Technical Service Bulletin No. 41

Created by: Music Tribe Brands Sweden AB Service Department

Date: 2017/11/20

Reference no: BP4DA1U

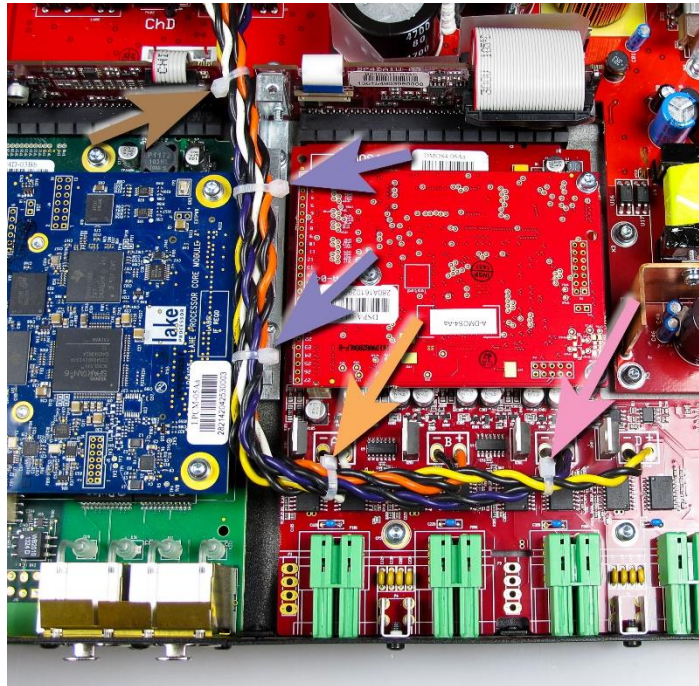
Replacement of the BP4DA1U-XXX ribbon-cables or replace the BP4DA1U-03Af

Modify BP4DA1U-XXX.

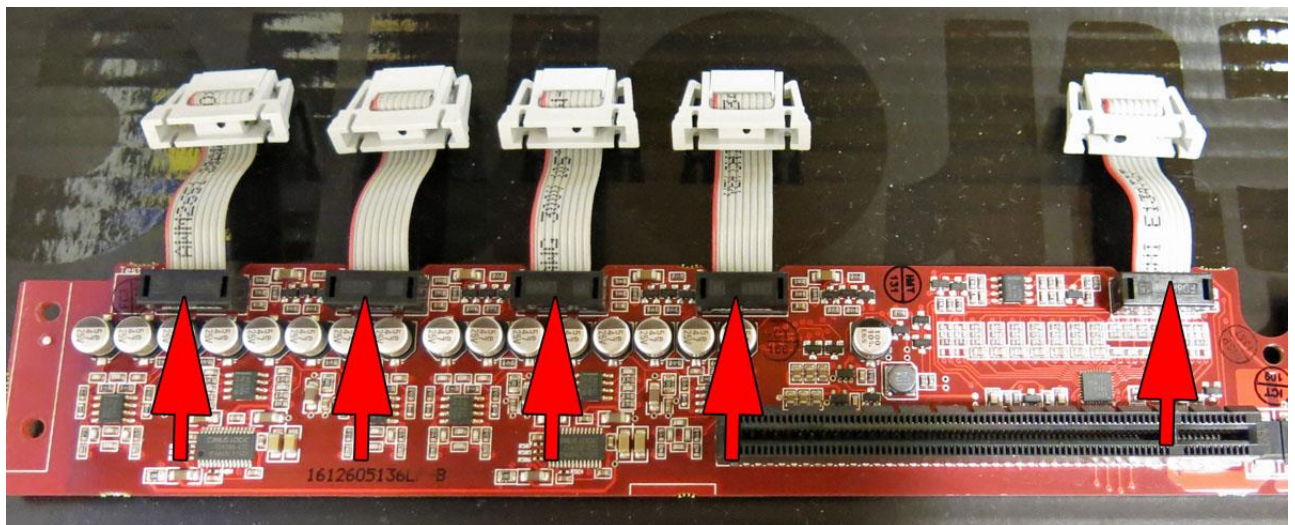
Replace highlighted ribbon-cables (5pcs). If you replace the cables make sure to write SB41 on the board
